## ORIGINATION FORM

Proposed Revisions to a Standard Plans Index  
(Please provide all information — Incomplete forms will be returned)

Index Number: 715-001  
Sheet Number (s): 1 OF 3  
Index Title: Conventional Lighting

Sheet 1: Changed fuse holder slug (blank) requirement from solid copper to manufacturer's suggested in three drawing locations.

INDEX	SHEET
715-001	1 of 3

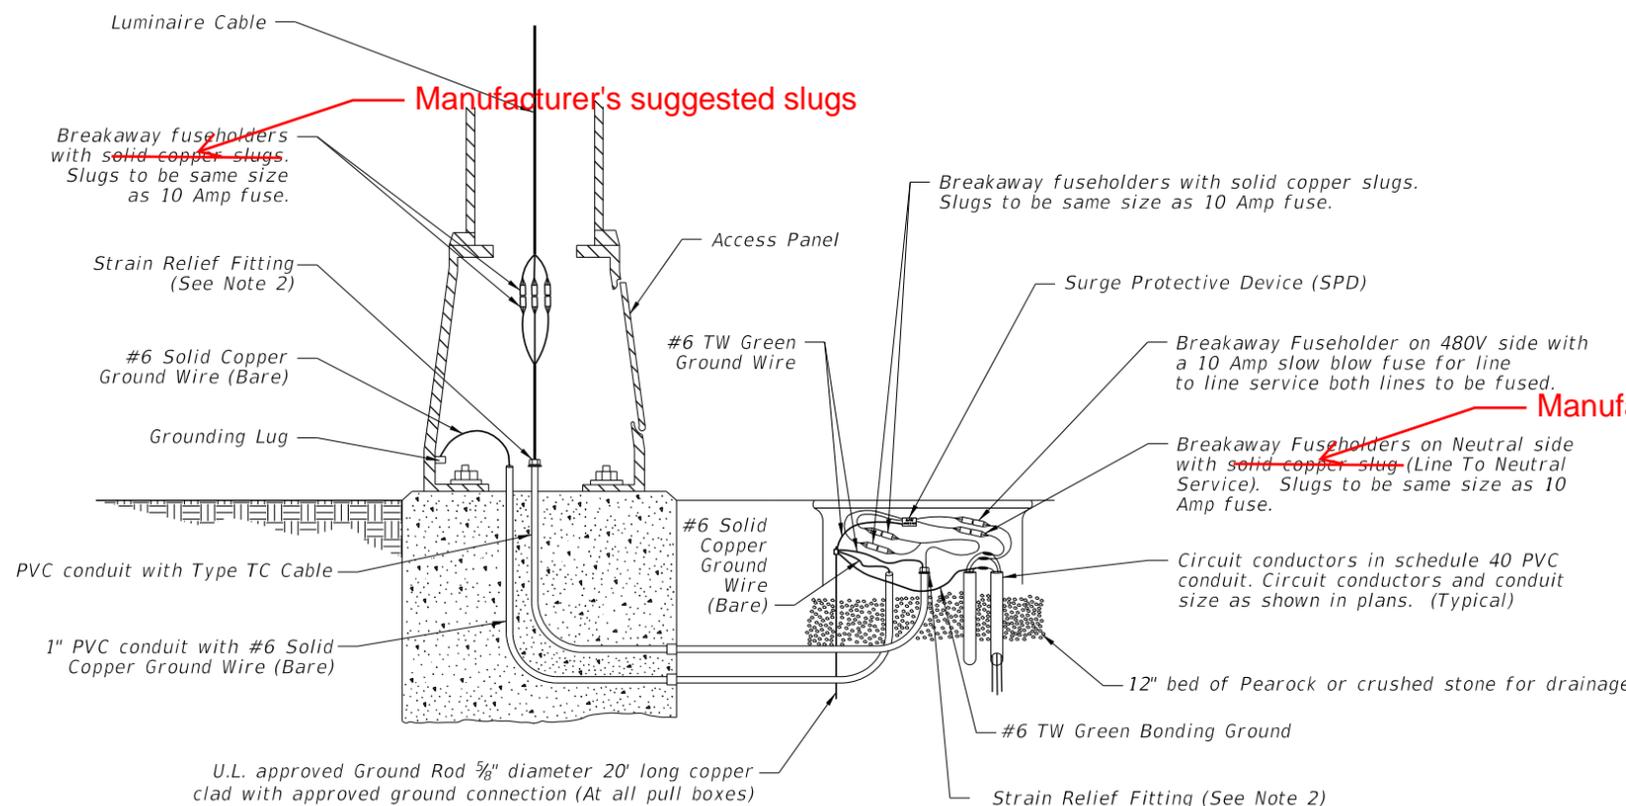
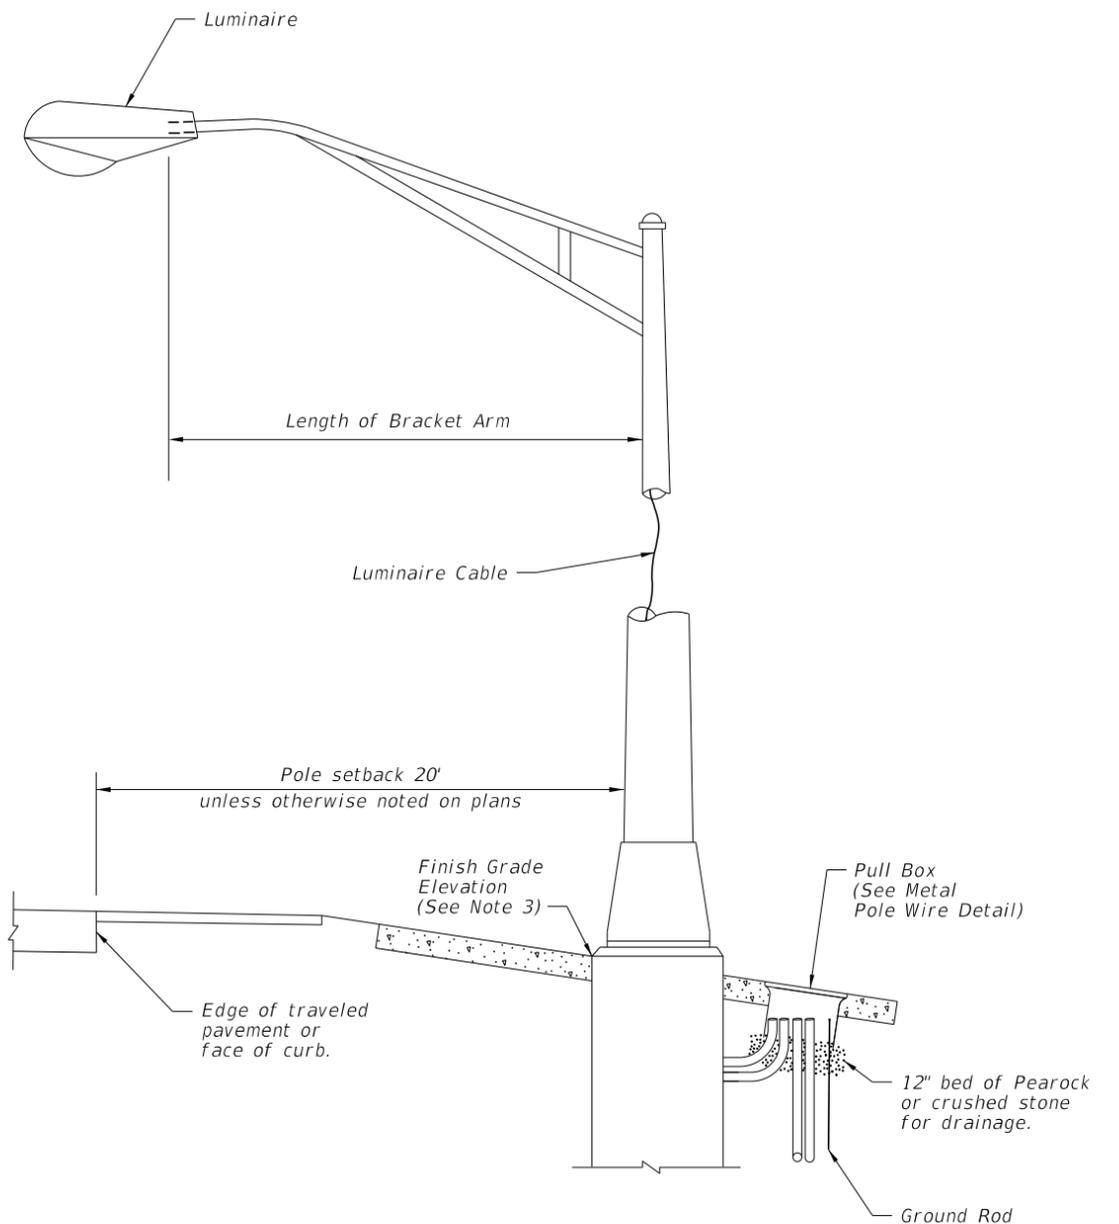
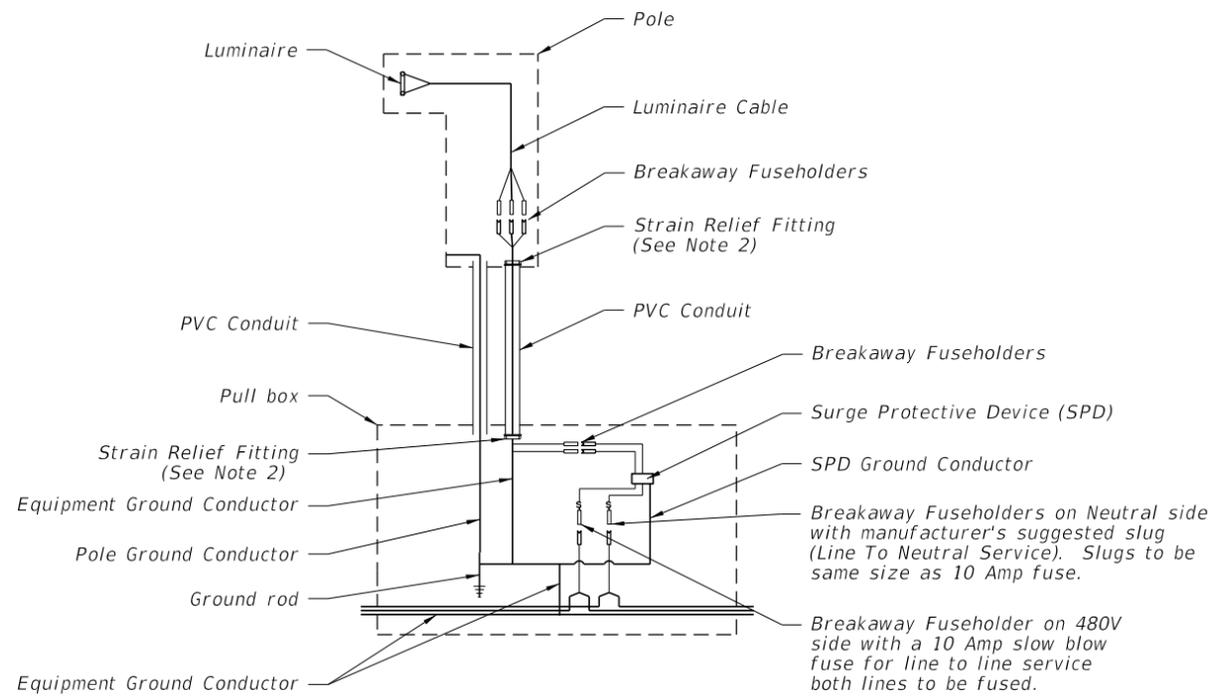
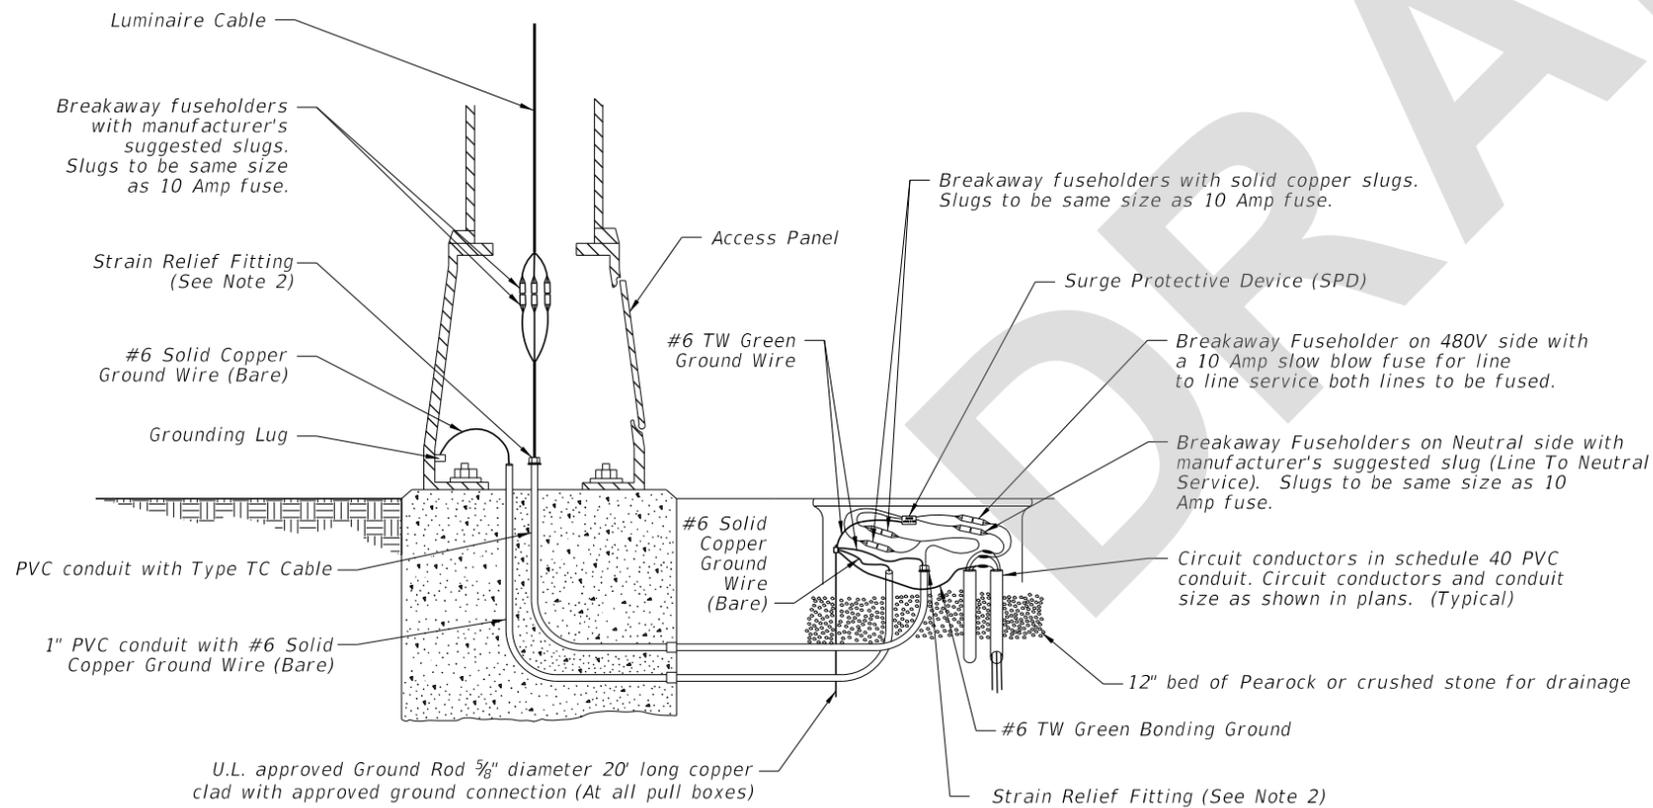
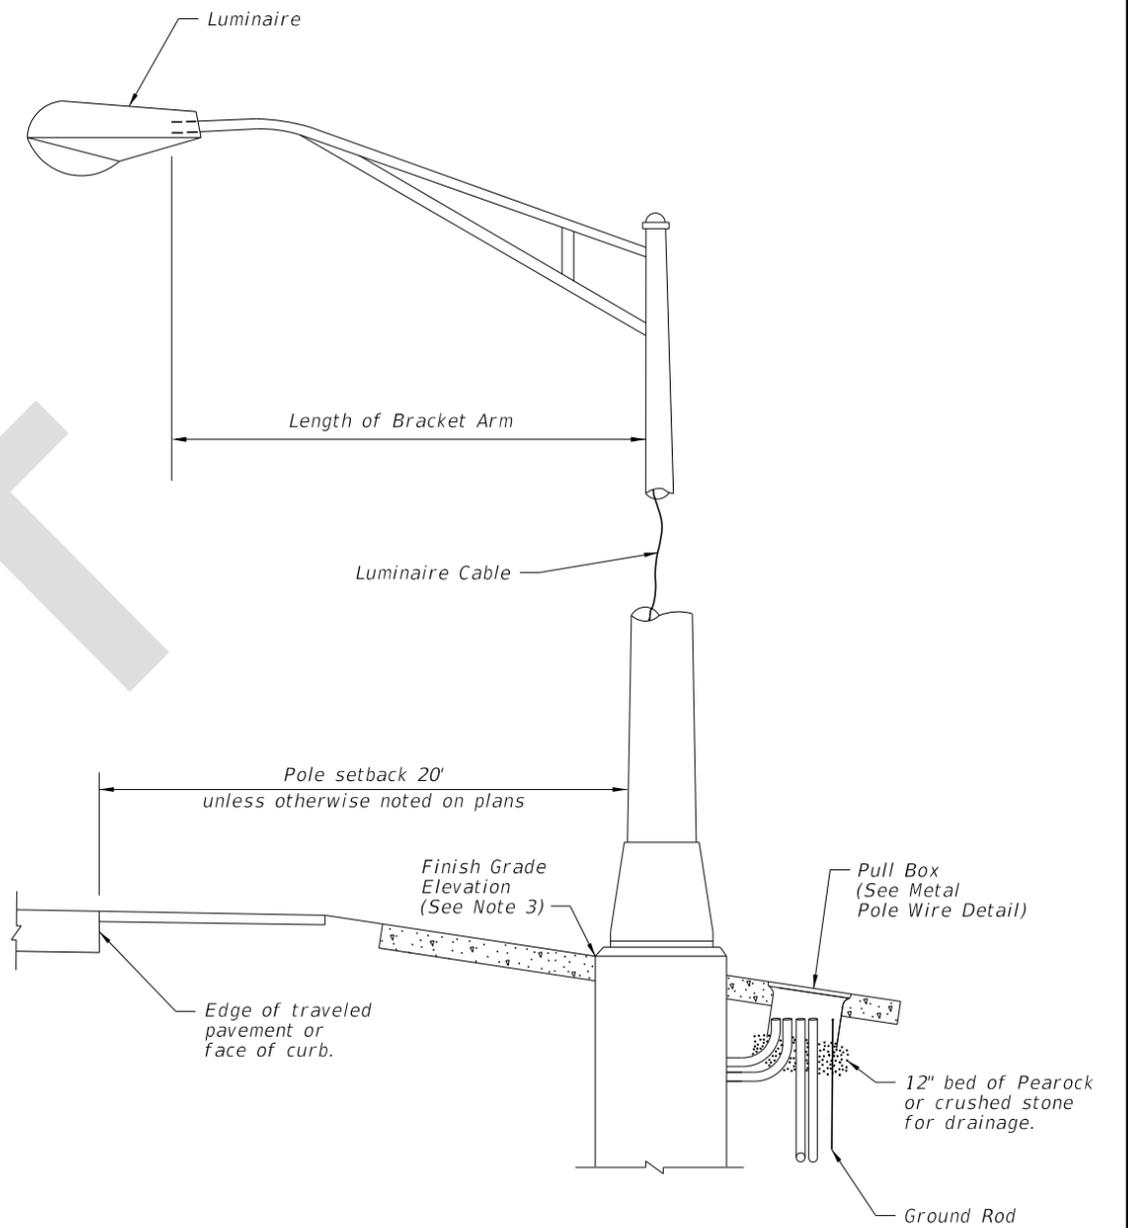
Industry advised that solid copper slug requirement is impractical and uncommon. Specification 992 is being revised to require the fuse holder manufacturer's suggested slug of copper equivalent (manufacturer generally responsible for performance of their product). This Standards change reflects the Specifications change.

Manufacturer's suggested slug

Manufacturer's suggested slug
